# Anowara Knit Composite Ltd. (10925)

ACCORD  
on Fire and Building Safety in Bangladesh

## Identified Priority 1 Concerns

1<sup>st</sup> Priority 1  
Concern

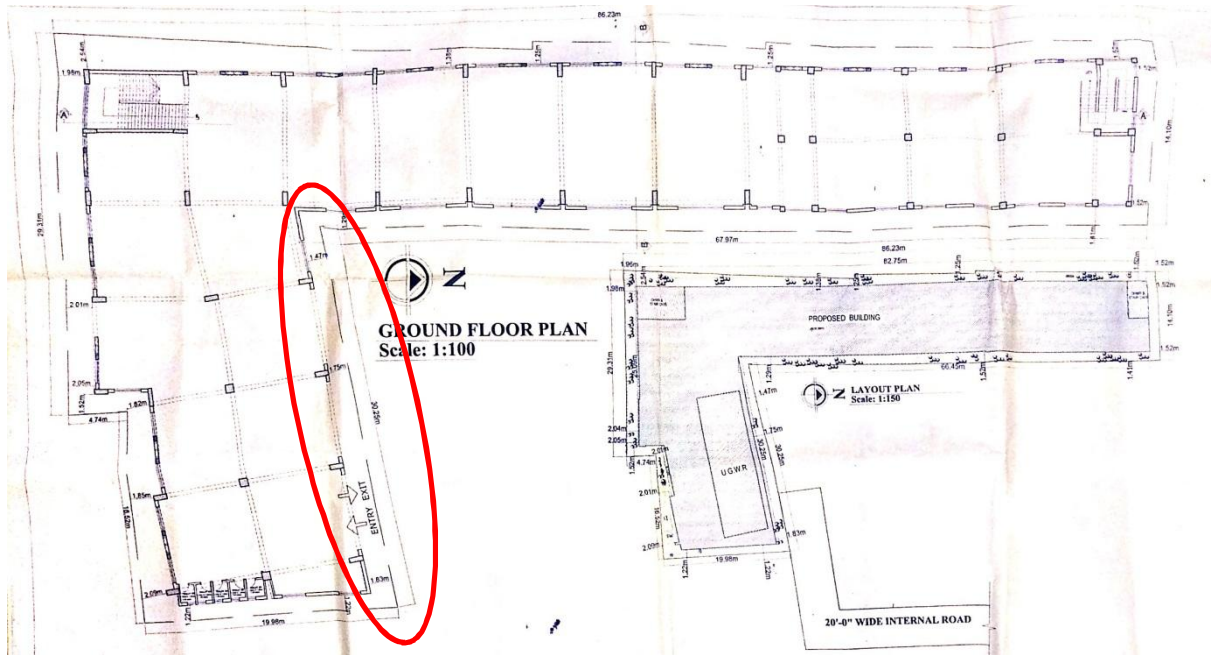
High storage loads were observed in buildings 6 & 7. In addition, no loading plans were made available for any of the buildings.

Maximum total floor loading was posted on a few levels, however the information displayed was not in a format that could be easily managed. In addition, this maximum loading was exceeded in building 6.

- Remove all storage down to 3.0 kPa.

- Carry out an Engineering Assessment on the buildings to determine capacity of floors.
- Produce loading plans in pounds per square foot (psf) format for each building.
- Manage loading plans.

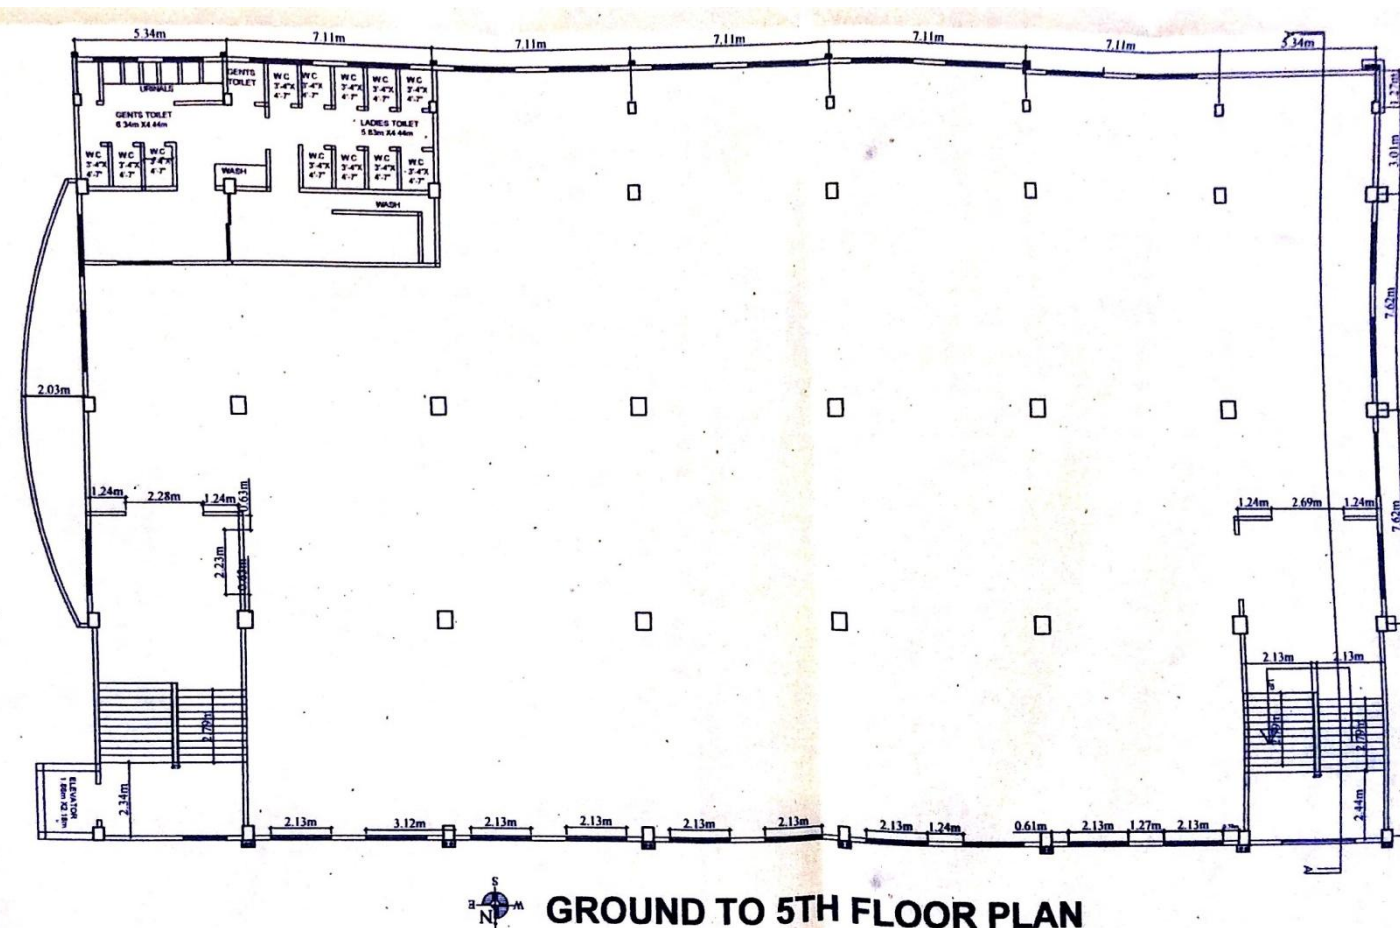
A steel plate covering old water storage tanks at building 6 appears inadequate. Large deflection was noted. In addition storage is loaded on the plate.

- Carry out Engineering Assessment on steel plate to determine load carrying capacity.

- Carry out any recommendations highlighted in Engineering Assessment.
